City of Albuquerque

September 3, 1999

**RE: GRADING & DRAINAGE PLAN FOR HUNTER'S RUN PARK (B-13/D7)
RECEIVED AUG 10, 1999 FOR DRC WORK ORDER
ENGINEER'S STAMP DATED 8/5/99**

CITY OF ALBUQUERQUE CAPITAL IMPLEMENTATION PROGRAM LANDSCAPE ARCHITECTURE AND CONSTRUCTION SERVICES	
TITLE: HUNTER'S RUN PARK IMPROVEMENTS	
GRADING AND DRAINAGE PLAN	
Design Review Committee	City Engineer Approval
Last Design Update	
City Project No. 573591	Zone Map No. B-13-Z
Sheet 6	Of 15

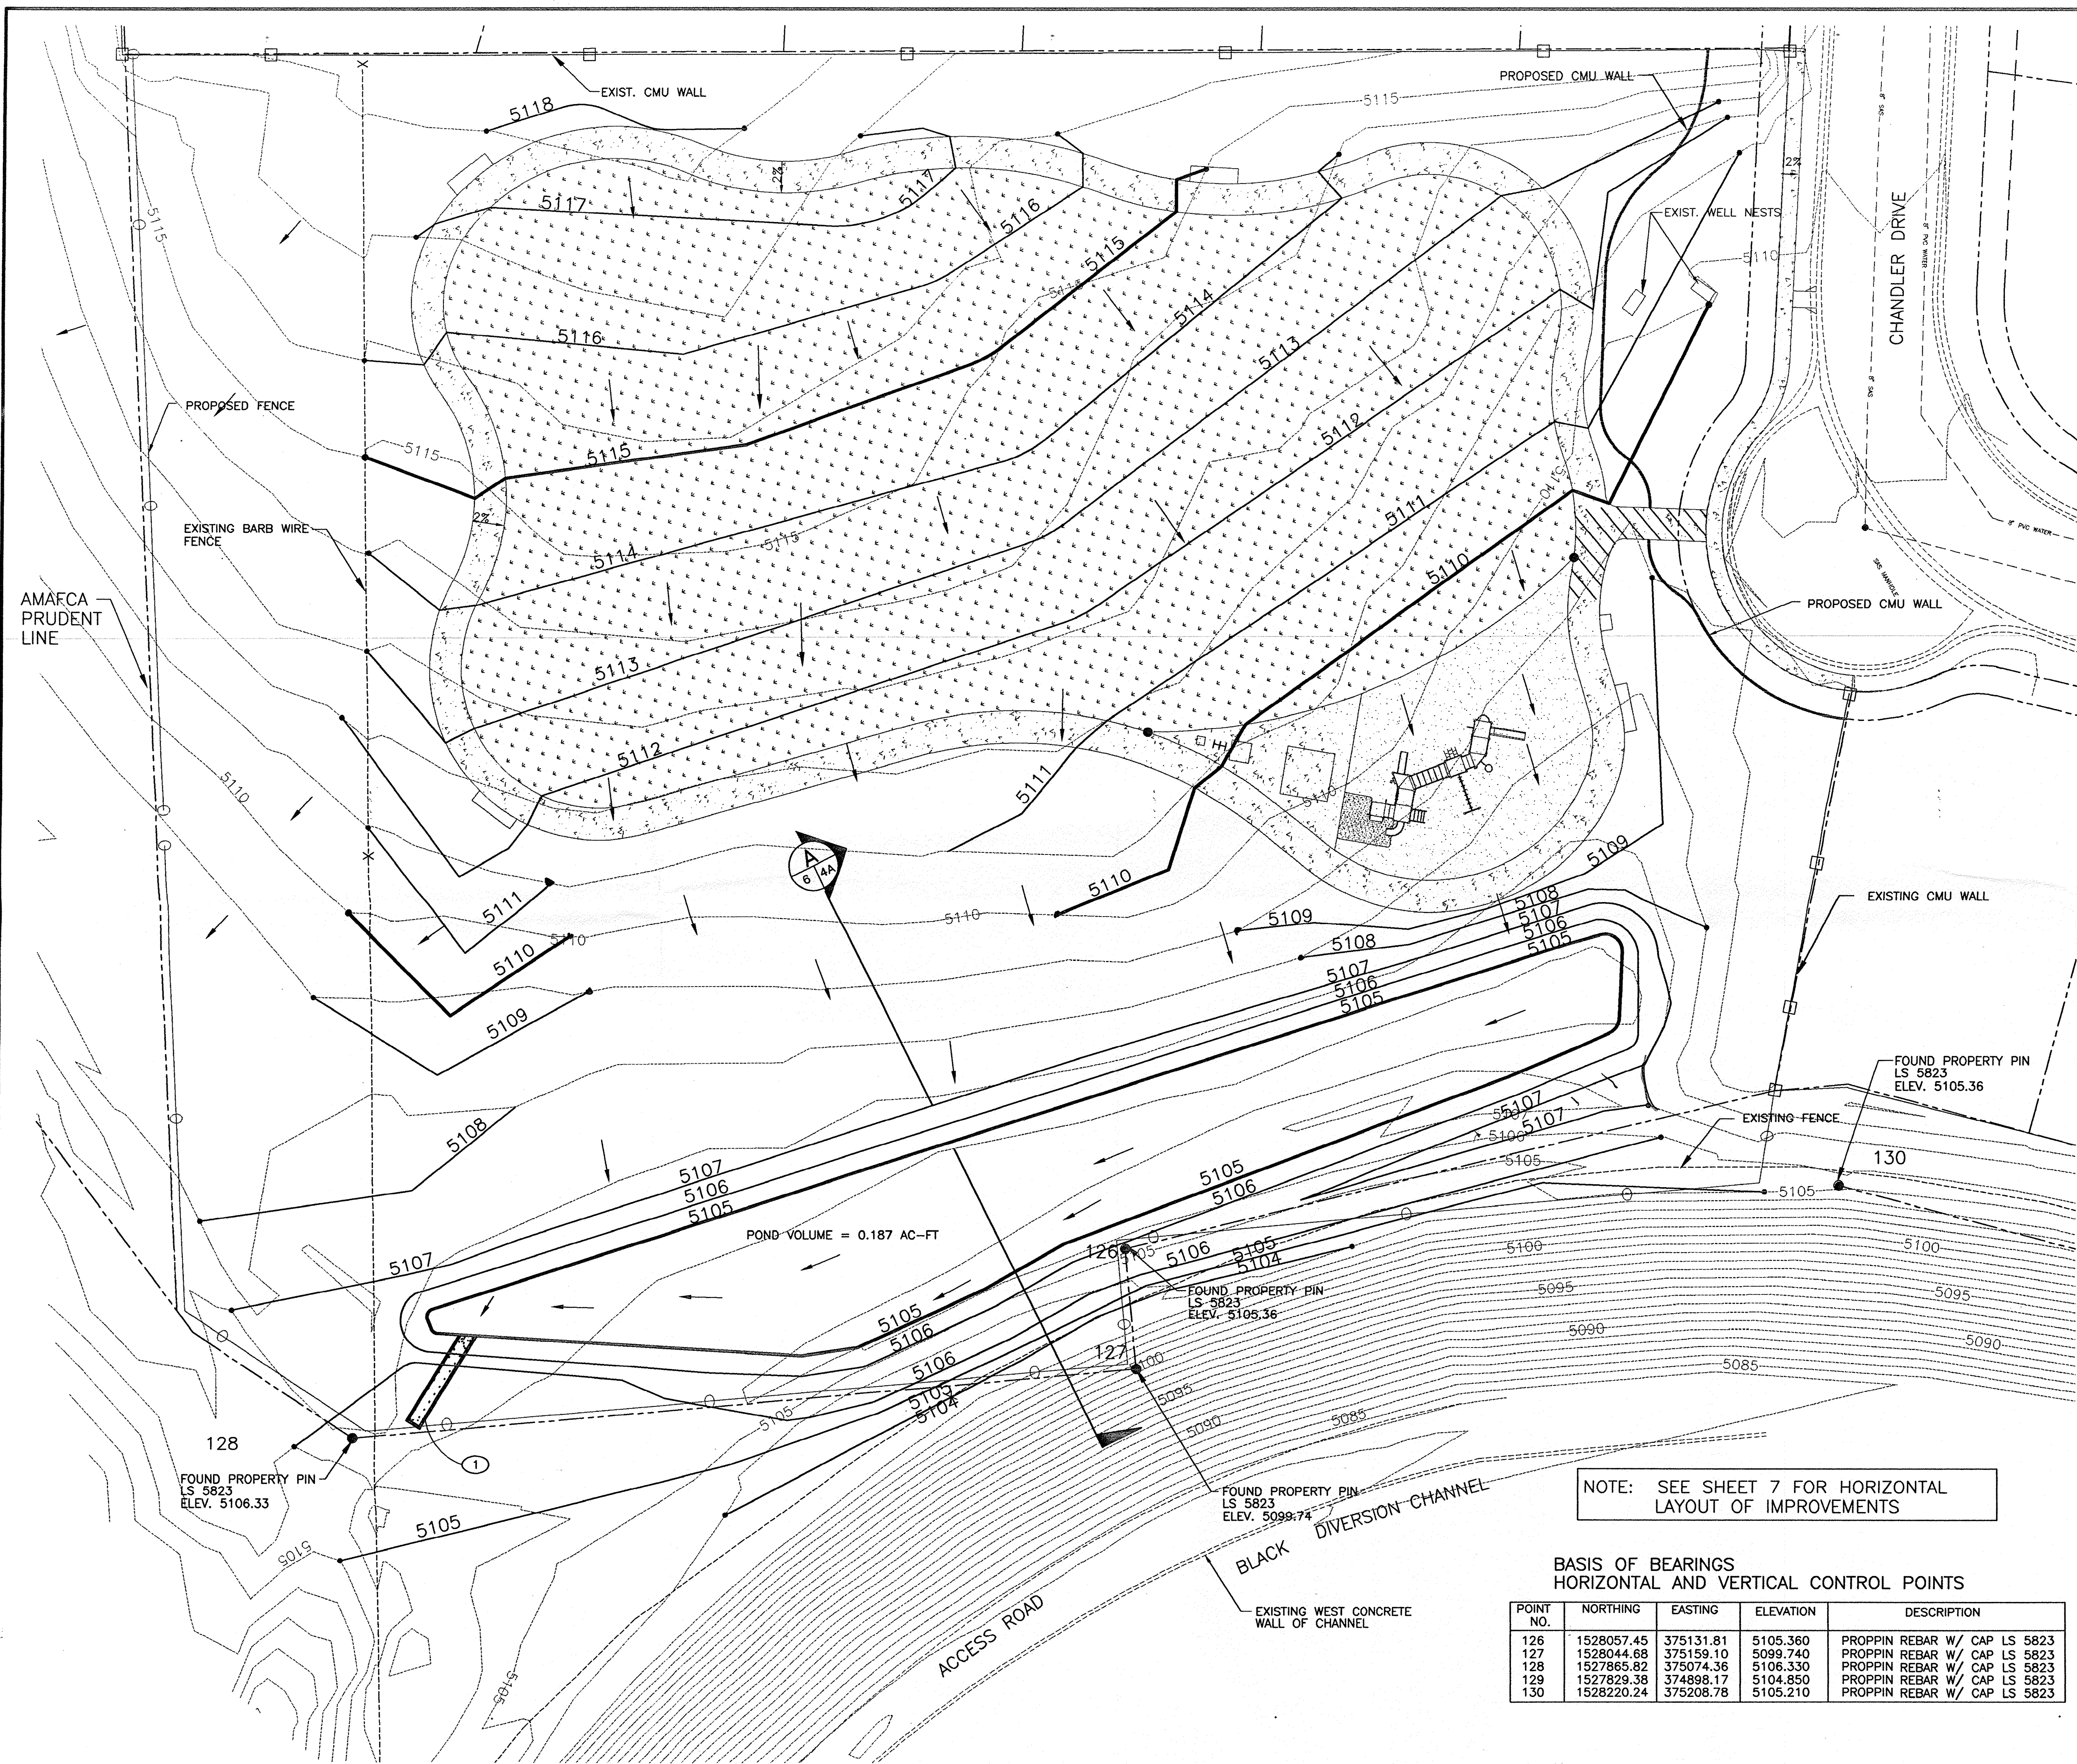
Based on the information included in the submittal referenced above, City Hydrology accepts the Grading & Drainage Plan for Work Order. Include a copy of the approved Grading & Drainage Plan, dated 8/5/99, in the set of construction drawing that will be submitted to the Design Review Committee for Work Order 5735.91.
